[1] REDLINE REVISION 11/28/05

REVISIONS	
B	2-15-05 SHA NO.: AT5665185 TRAFFIC SIGNAL RECONSTRUCTION, SYSTEMIZATION AND REDLINE REVISION NO. 1
A	Reconstruct Traffic Signal

MARYLAND DOT - STATE HIGHWAY ADMINISTRATION
Office of Traffic & Safety
TRAFFIC ENGINEERING DESIGN DIVISION

US 1 AND QUEENSBURY ROAD

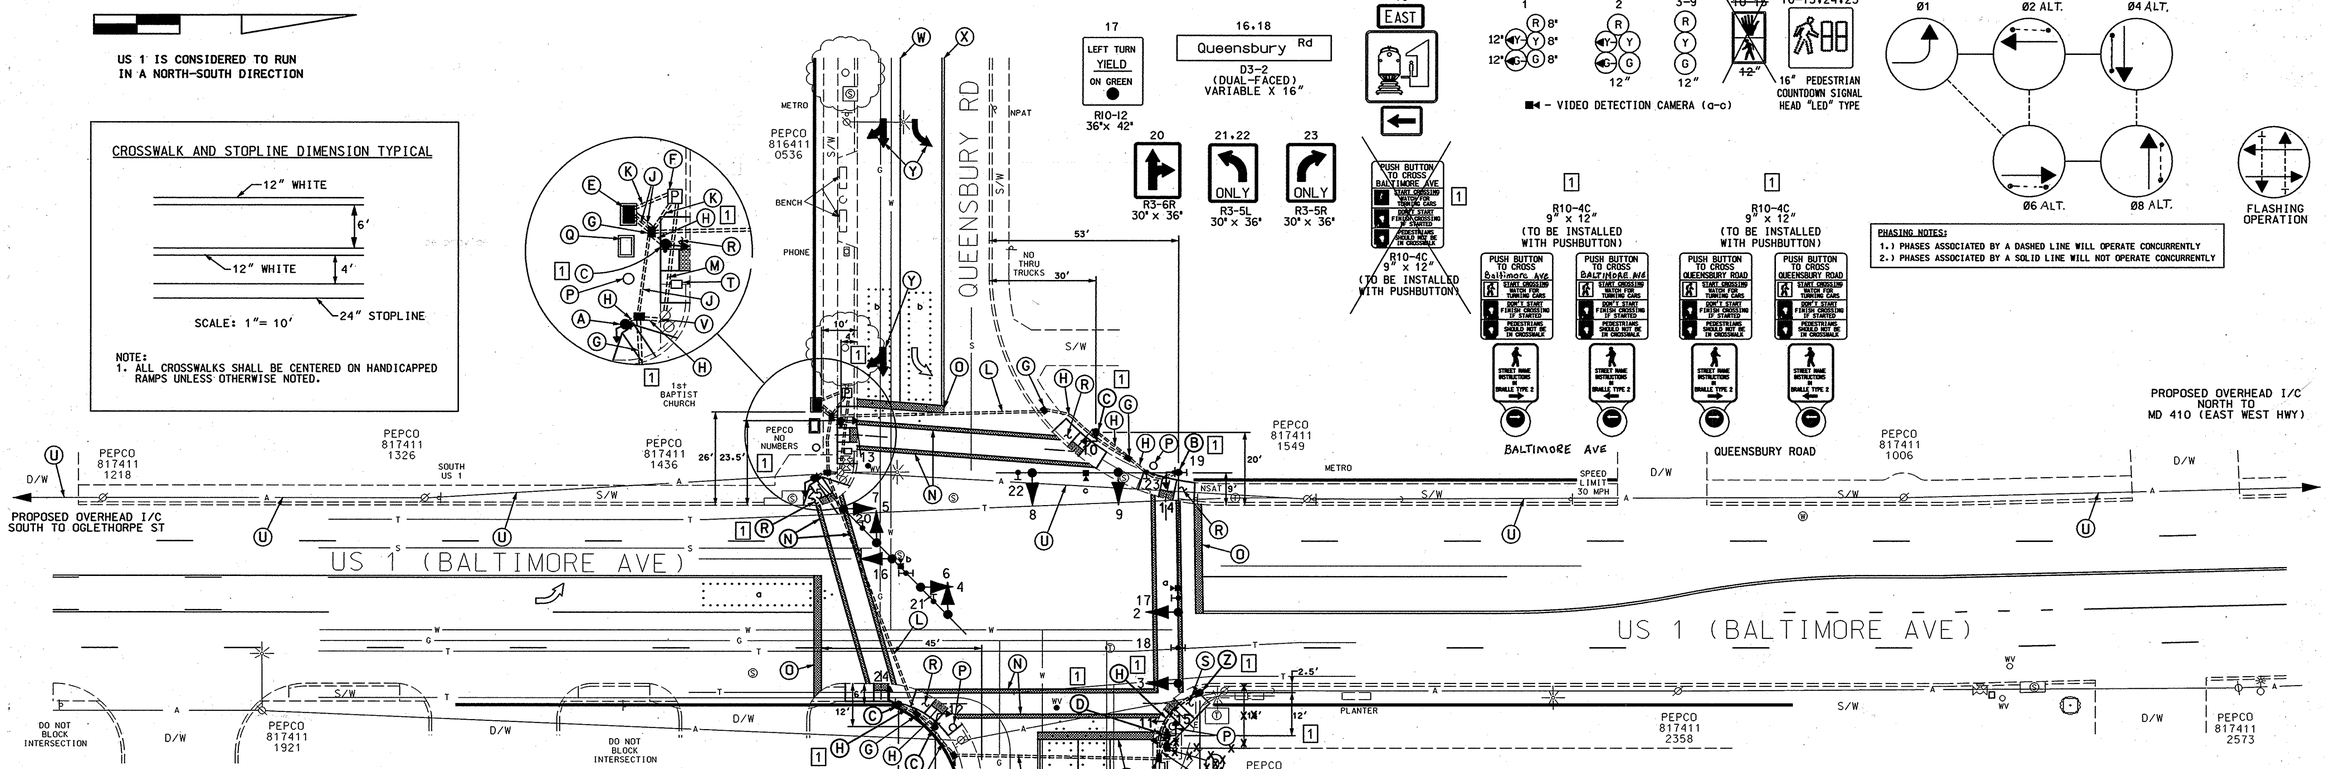
[1] B. Install 16' steel pole with a special 15' "T" dimension twin 50'/60' mast arms, traffic signal heads, countdown pedestrian signal head, APS pushbutton, pedestrian education sign and video detection camera as shown. (Note: 1-3", 90° polyvinyl chloride (Schedule 80) bend.)

[1] C. Install 10' pedestal pole with countdown pedestrian signal heads, APS pushbutton and pedestrian education sign as shown. (Note: 1-3", 90°polyvinyl chloride (Schedule 80) bend.)

[1] D. Install 10' pedestal pole with pedestrian signal heads, pushbutton and pedestrian education sign as shown. (Note: 1-3", 90°polyvinyl chloride (Schedule 80) bend.)

[1] Z. Install 4' pedestal pole with APS pushbutton and pedestrian education sign as shown. (Note: 1-3", 90°polyvinyl chloride (Schedule 80) bend.)
